Causation Factors for the Banjar Panji No. 1 Blowout

***Neal Adams Services
September 15, 2006
Jakarta, Indonesia***

RE: Report as Per Consulting Services Agreement
Causation Factors for the Banjar Panji No. 1 Blowout

Figure 5.2 Seismic Data Showing Faults and the BJP well.

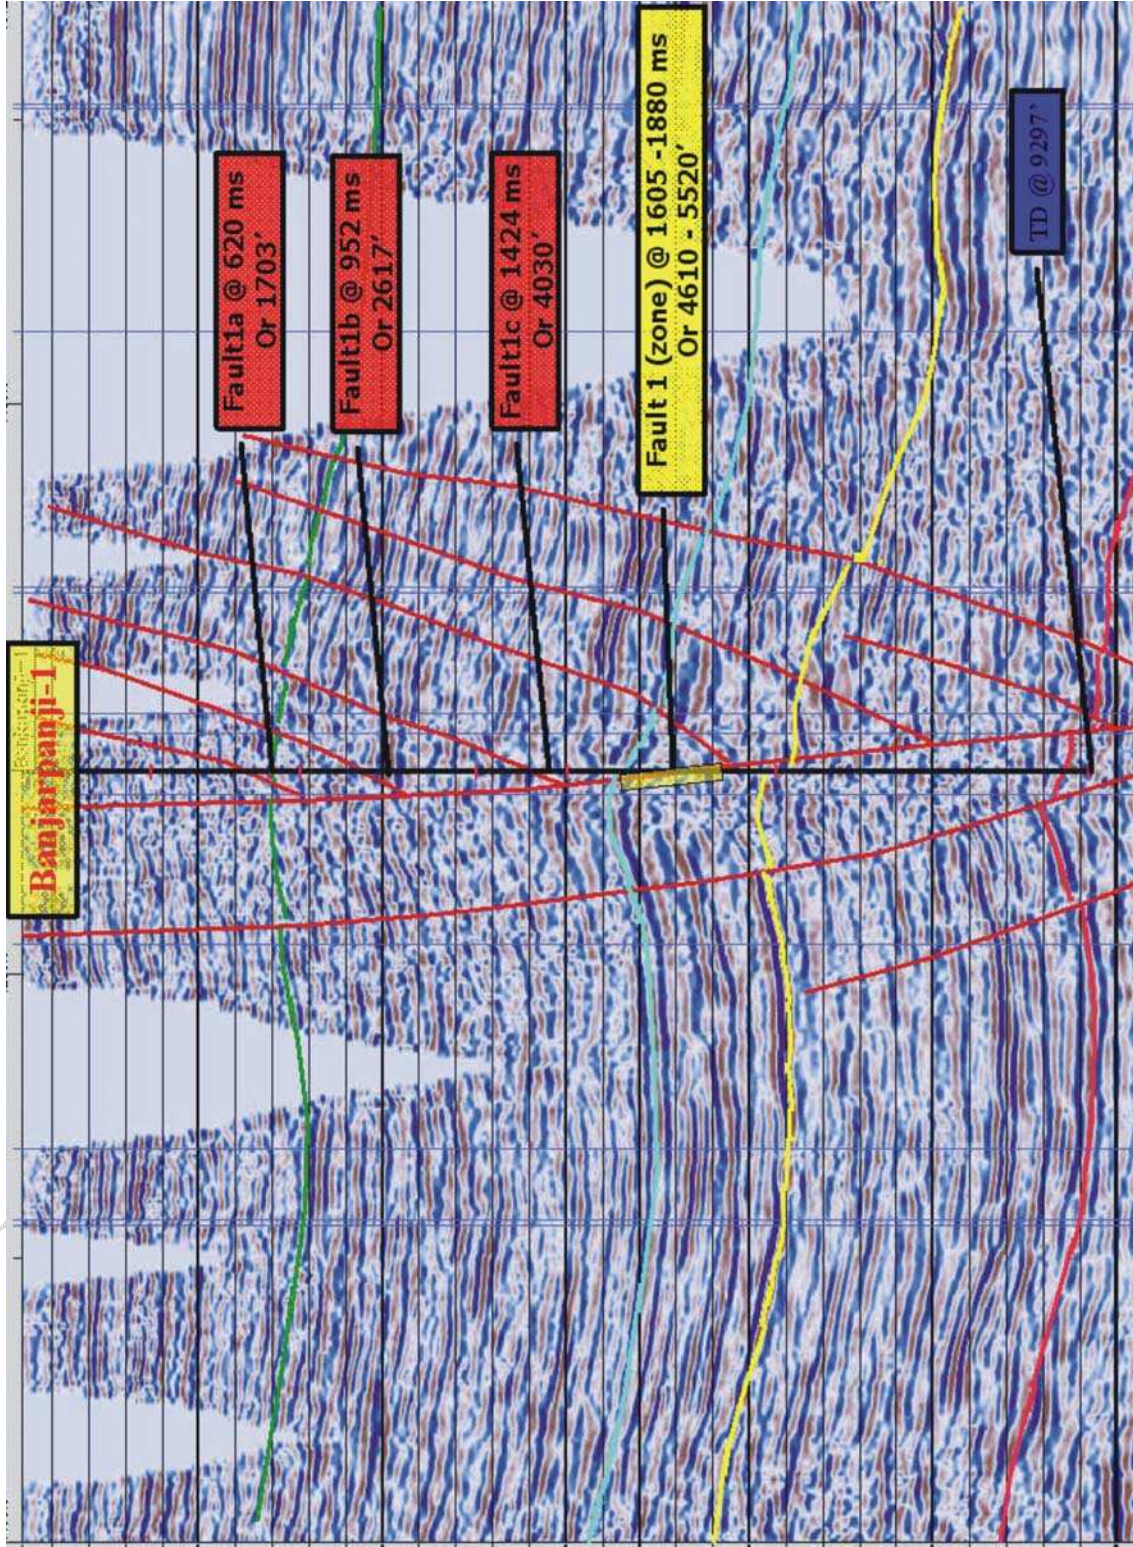
Figure 5.2 shows the shot line most proximate to the site location for the Banjar Panji well. Pertinent faults have been emphasized with red lines by the MEDCO seismic group. A prime fault intersects the Banjar Panji well at 4,610 feet to 5,520 feet. The type of faulting seen in Figure 5.2 is common to salt or mud diapirs.

It is likely that most of the faults shown in Figure 5.2 are sealed, primarily due to the hydratable clays in the shale deposition region. The faults should remain sealed and not pose any drilling problems unless some tectonic activity occurs.

Drill site selection in a faulted area such as that shown in Figure 5.2 must be done with caution. Faults can be associated with lost circulation and unstable hole conditions. Kick fluids can move through sections of a fault if unsealed.

It is recommended to avoid selected a drill site in an area proximate to a fault(s). If a requirement for drilling exists, the recommended approach is to select a site in a fault-free area and directional drill to the primary target. Proper planning is important and should involve individuals from seismic, geology and drilling groups.

Figure 6.1 Comparison of “As Planned” and “As Drilled” Geology

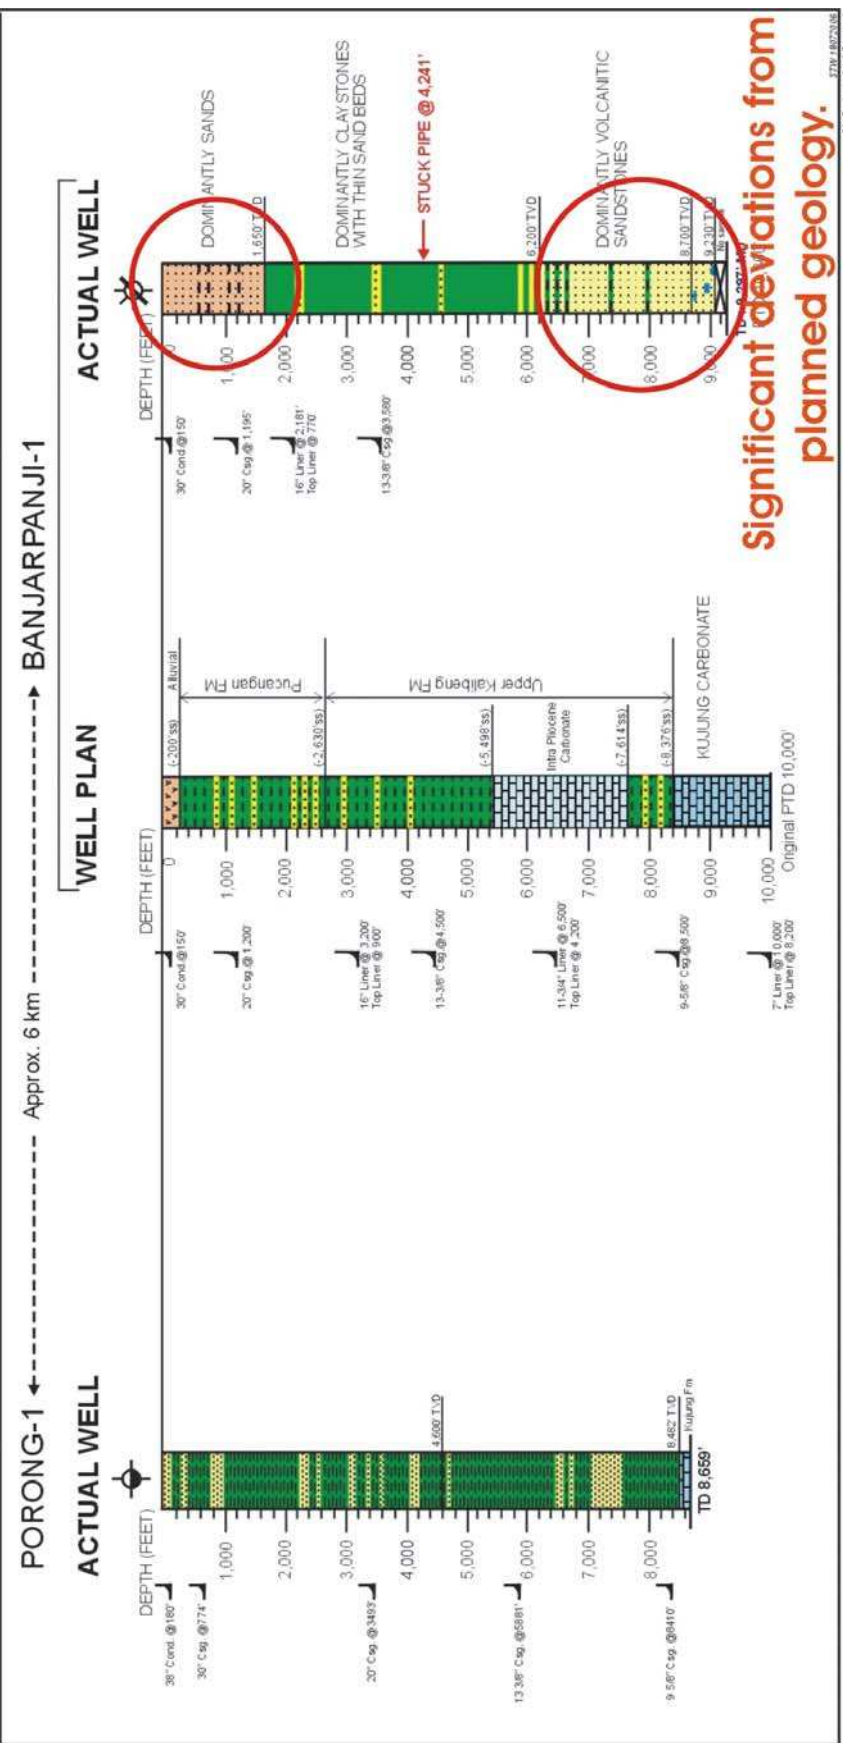
Figure 6.1 illustrates the "As Planned" and "As Drilled" geology. The figure also shows the Porong 1 well, which was used as an offset guide. It is quickly apparent that the "As Drilled" geology in the Banjar Panji No. 1 well is substantially different than the "As Planned" geology. The region below ~6,000 feet is comprised of volcanic sandstone. Also, the 0 – 1,500 feet region shows variations.

The substantially different geological conditions between "As Planned" and "As Drilled" should have given rise to intensive discussions and a re-evaluation of the Well Plan as soon as the new conditions were observed. The Well Plan for the Banjar Panji well "As Planned" would probably require some modification before the well could be safely drilled. However, uncertainty associated with the geology in the deeper hole section made it unlikely that the well could be confidently drilled and not pose hazards. The available information used in preparing this report does not contain any indication that Lapindo gave any consideration to the necessary modifications to the Well Plan.

Figure 7.1 "As Planned" Well Schematic

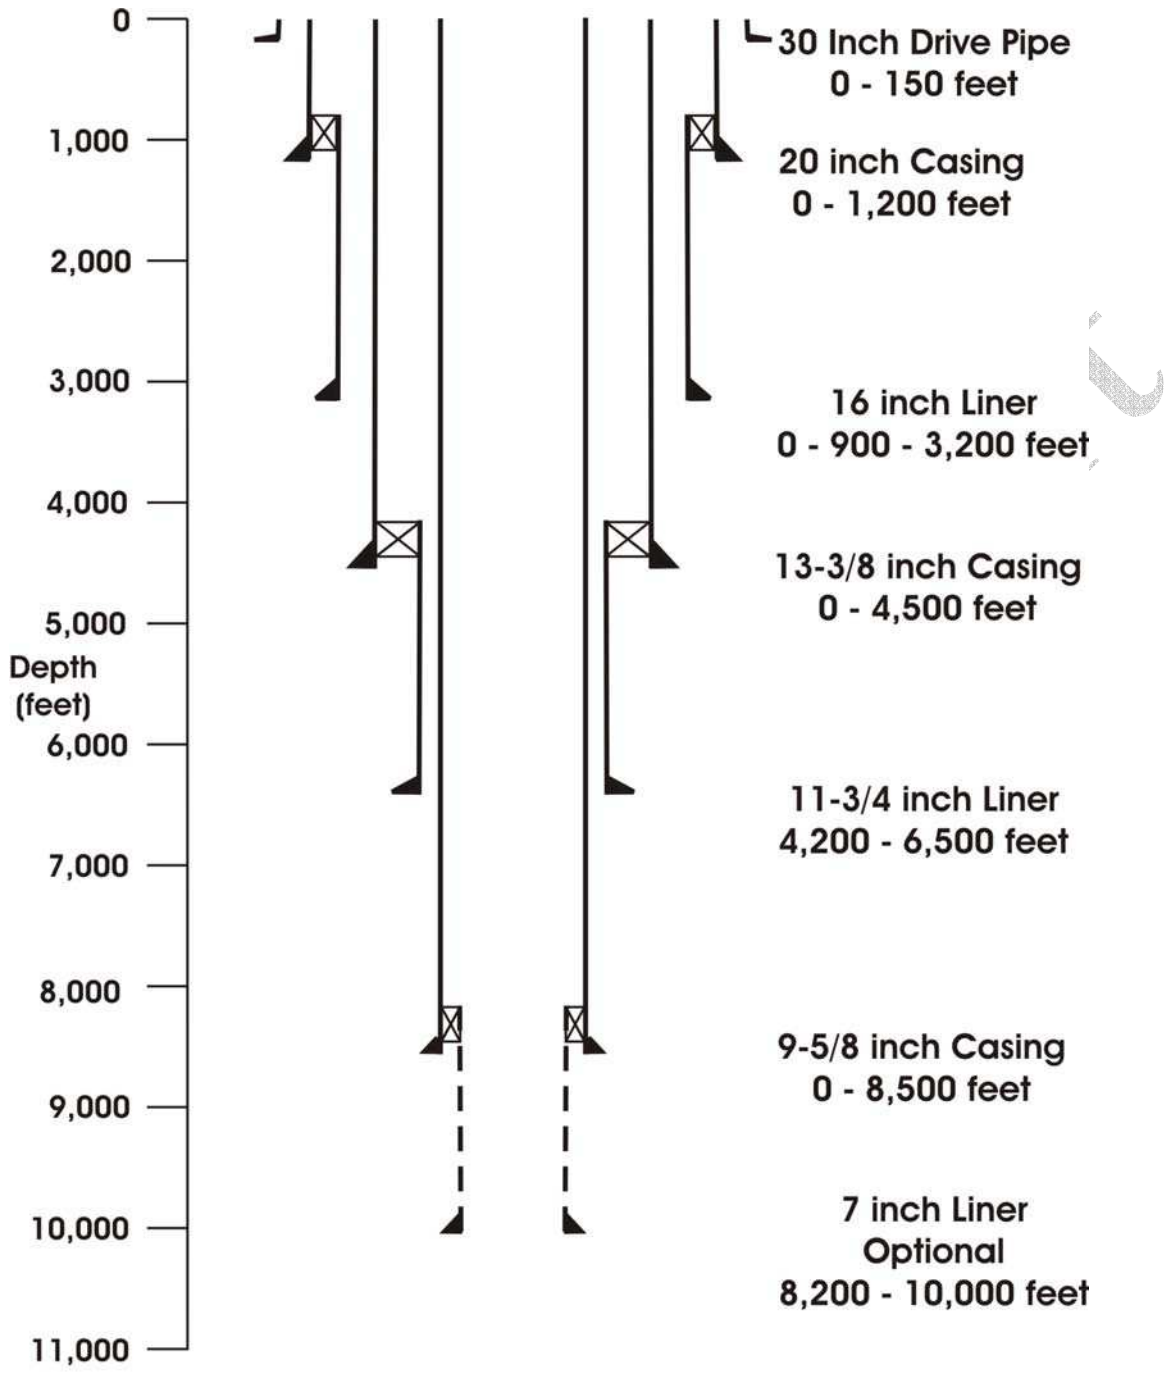
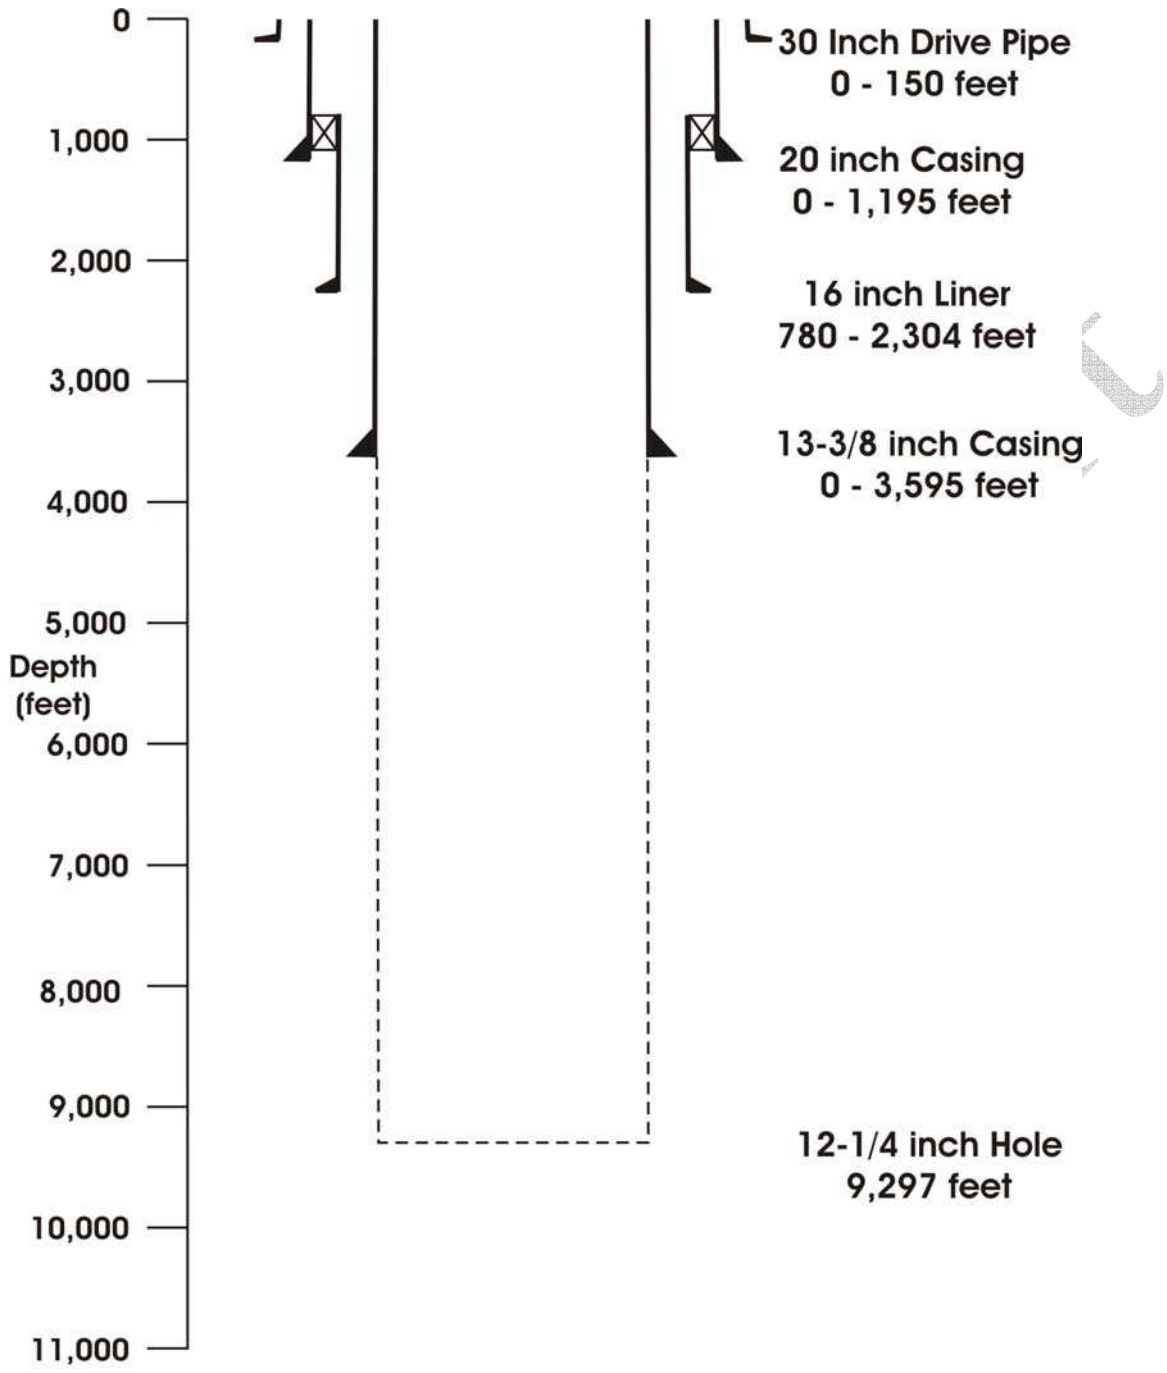
Figures 7.1 and 7.2 show the “As Planned Well Schematic and the “As Drilled Well Schematic”. (Figures shown at the end of Section 3.) Figure 7.2 can be used to note that the planned casing strings at 6,500 feet and at ~9,000 feet were not run. Running and cementing either or both pipe strings should have prevented the blowout.

The proposed well schematic shown in Figure 7.1 is improperly designed to address the formation pressures in Figure 7.3. Nonetheless, it is likely this well schematic would have prevented the blowout if it had been properly implemented.

Figure 7.3 Anticipated Pore Pressure/Fracture Pressure Conditions for the Banjar Pangi 1 Well

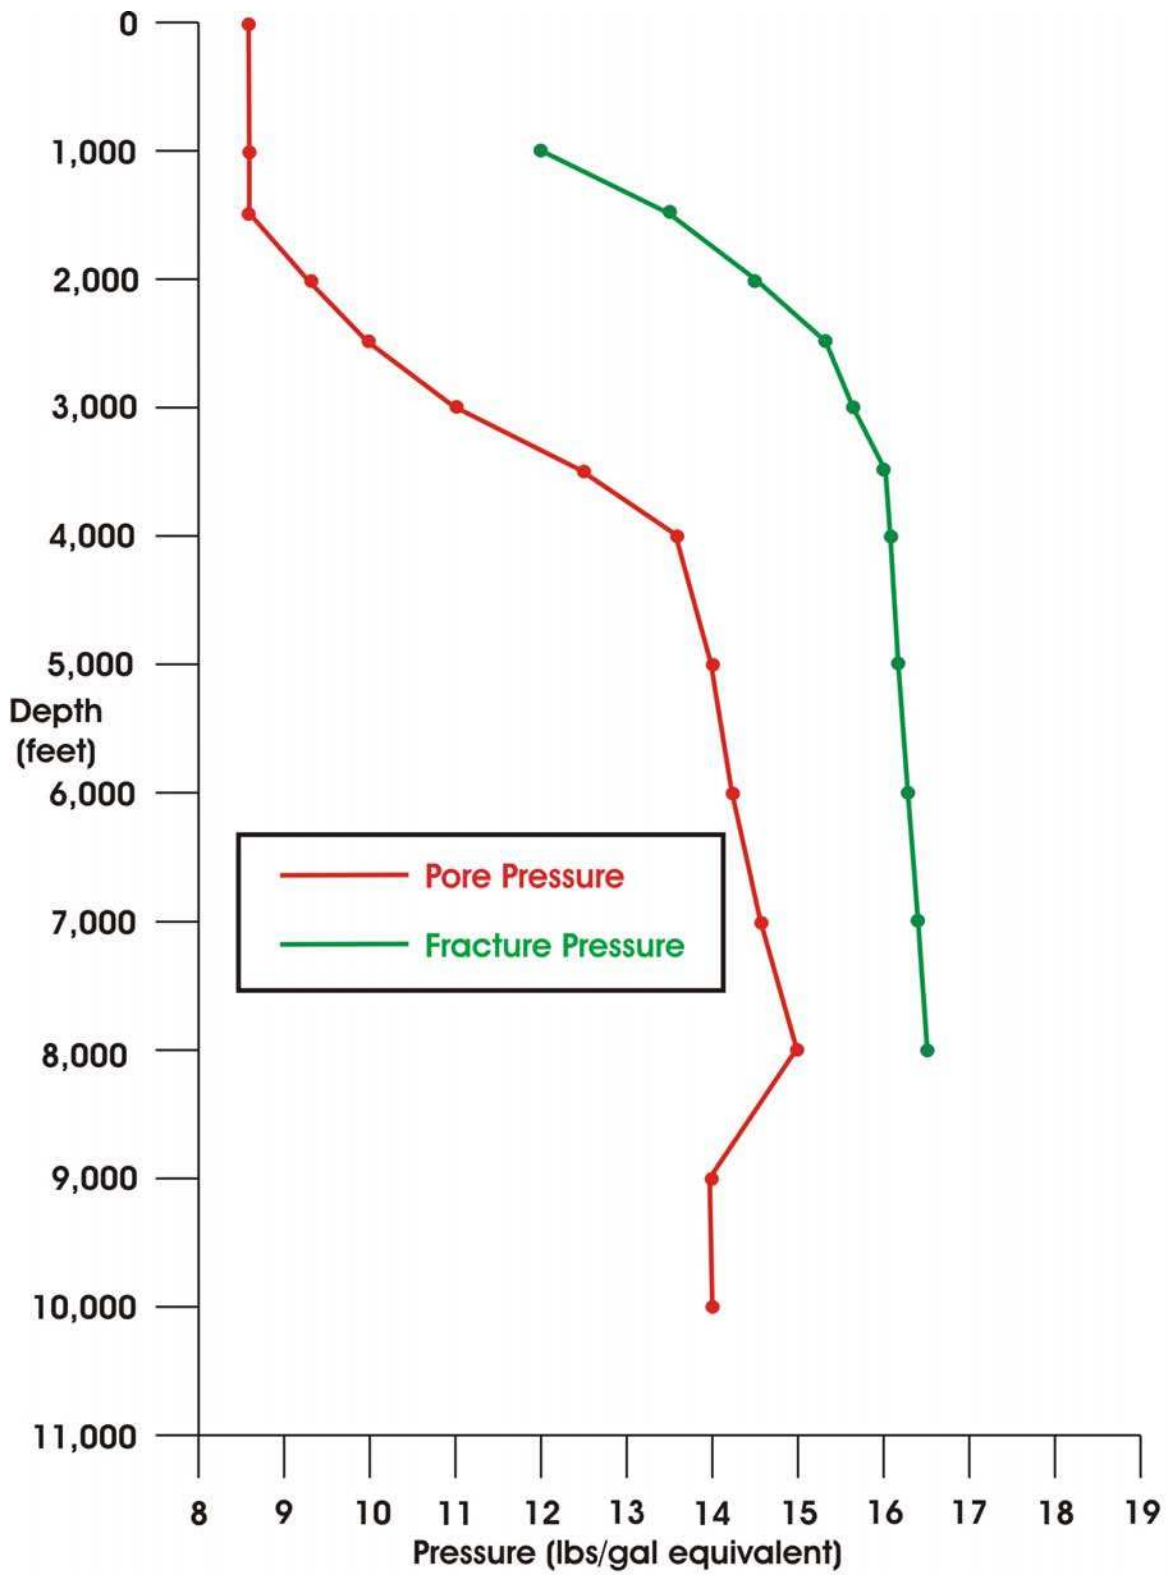
Figure 7.3 shows the anticipated pore pressures and fracture pressures for the BJP well. The Well Plan does not indicate the source of this critical data. The fracture pressures from 0 – 2,000 feet were not provided. Also, the same pressures for the 8,000 feet to 10,000 feet interval were not available. A proper well plan can not be generated without a complete understanding of fracture pressures throughout all sections of the well.
